PRODUCT CHANGE NOTIFICATION COVERSHEET

CTS Part Number: Model 632, 636,
CB1V8, CB2V5

Product Description: HCMOS Clock Oscillator

Reason for PCN: Change notification for revised product marking format.

Model 632 [drawing 008-0328-0]

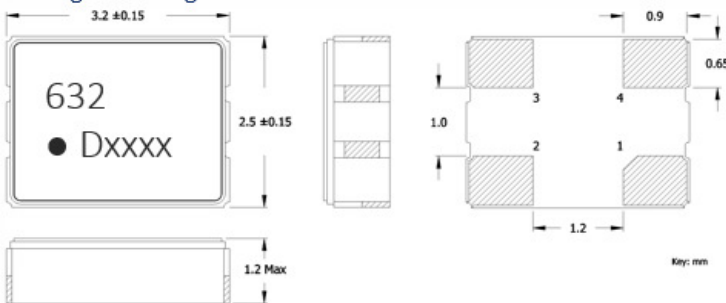
Change To - New Format, Revision F]

Marking Information

1. 632 – CTS Model.
2. D – Date Code. See Table I for codes.
3. xxxx – Frequency Code.
3-digits, frequencies below 100MHz
4-digits, frequencies 100MHz or greater
[See document 016-1454-0, Frequency Code Tables.]

Change From - Old Format, Revision E]

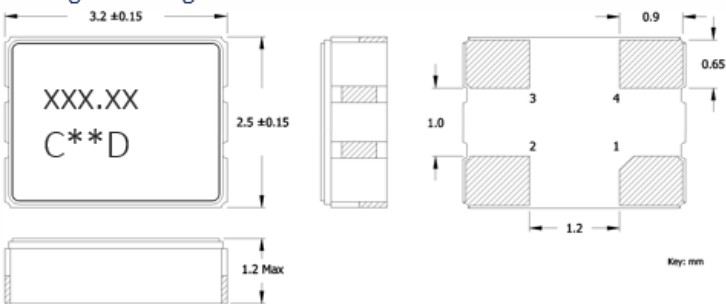
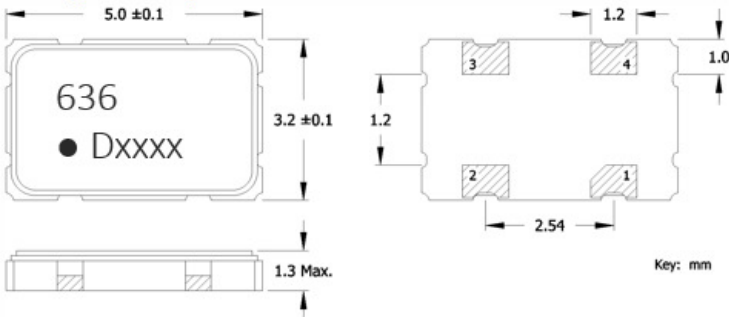
Marking Information

1. xxx.xx – Frequency in MHz.
Frequency is marked with 1 - 3 leading significant digits before and 2 significant digits [including zeroes] after the decimal.
Marking Examples:
3.57954MHz = 3.57
14.31818 MHz = 14.31
125MHz = 125.00
2. C – CTS and Pin 1 identifier.
3. ** – Manufacturing Site Code.
4. D – Date Code. See Table I for codes.

Model 636 [drawing 008-0250-0]

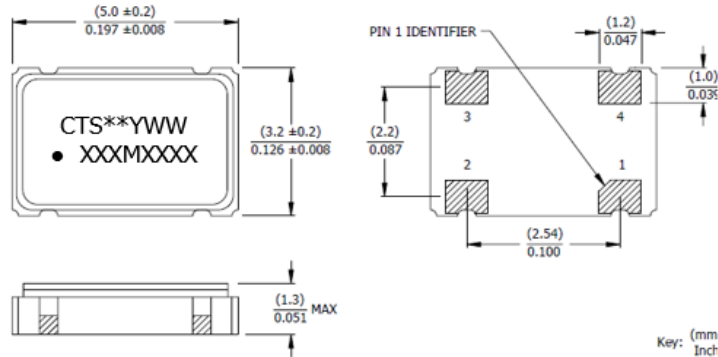
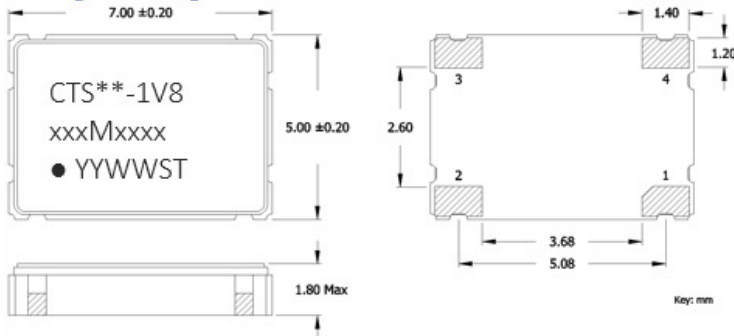
Change To - New Format, Revision J]

Marking Information

1. 636 – CTS Model.
 2. D – Date Code. See Table I for codes.
 3. xxxx – Frequency Code.
3-digits, frequencies below 100MHz
4-digits, frequencies 100MHz or greater
- [See document 016-1454-0, Frequency Code Tables.]

Change From - Old Format, Revision I]

MARKING INFORMATION

1. ** - Manufacturing Site Code.
2. YWW – Date code, Y – year, WW – week.
3. XXXMXXXX – Frequency is marked with only leading significant digits before the 'M' and 4 digits after the 'M' [including zeros].
Ex. XXMXXXX [62M5000]
XXMXXXX [155M5200]

Model CB1V8 [drawing 008-0277-0]

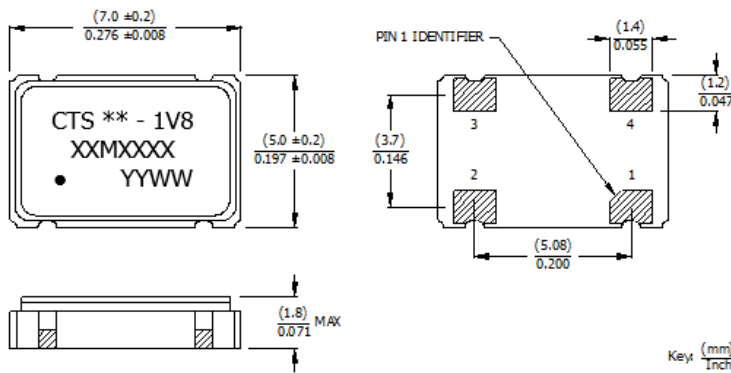
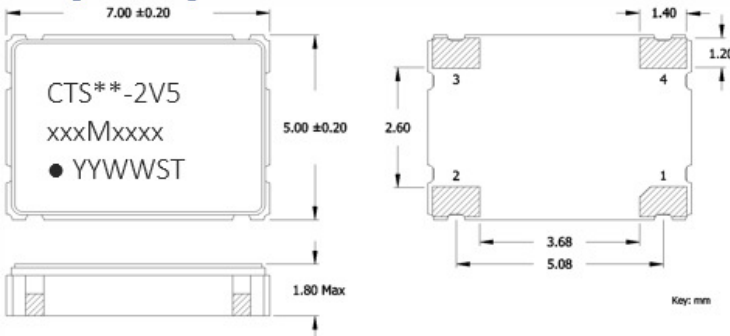
Change To - New Format, Revision C]

Marking Information

1. ** – Manufacturing Site Code.
2. xxxMxxxx – Frequency is marked with 1,2 or 3 leading significant digits before the “M” and 4 digits after the “M” [including zeroes].
Ex. xMxxxx [3M5795]
xxMxxxx [14M3181]
xxMxxxx [25M0000]
xxxMxxxx[125M0000]
3. YYWW – Date Code; YY = year, WW = week.
4. ST – Frequency Stability/Temperature Code.
[Refer to ordering information for codes.]

Change From - Old Format, Revision B]

MARKING INFORMATION

1. ** - Manufacturing Site Code.
2. XXMXXXX - Frequency marked with 4 significant digits after the 'M'.
3. YYWW – Date code, YY – year, WW – week.

Model CB2V5 [drawing 008-0281-0]

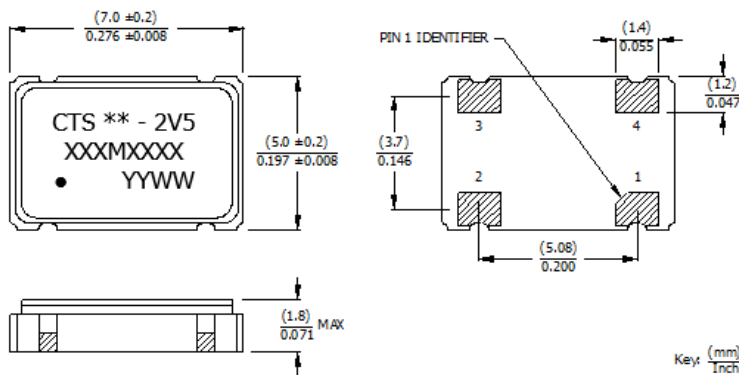
Change To - New Format, Revision C]

Marking Information

1. ** – Manufacturing Site Code.
2. xxxMxxxx – Frequency is marked with 1,2 or 3 leading significant digits before the “M” and 4 digits after the “M” [including zeroes].
Ex. xMxxxx [3M5795]
xxMxxxx [14M3181]
xxMxxxx [25M0000]
xxxMxxxx[125M0000]
3. YYWW – Date Code; YY = year, WW = week.
4. ST – Frequency Stability/Temperature Code. [Refer to ordering information for codes.]

Change From - Old Format, Revision B]

MARKING INFORMATION

1. ** - Manufacturing Site Code.
2. XXXMXXXX - Frequency marked with 4 significant digits after the “M”.
3. YYWW – Date code, YY – year, WW – week.
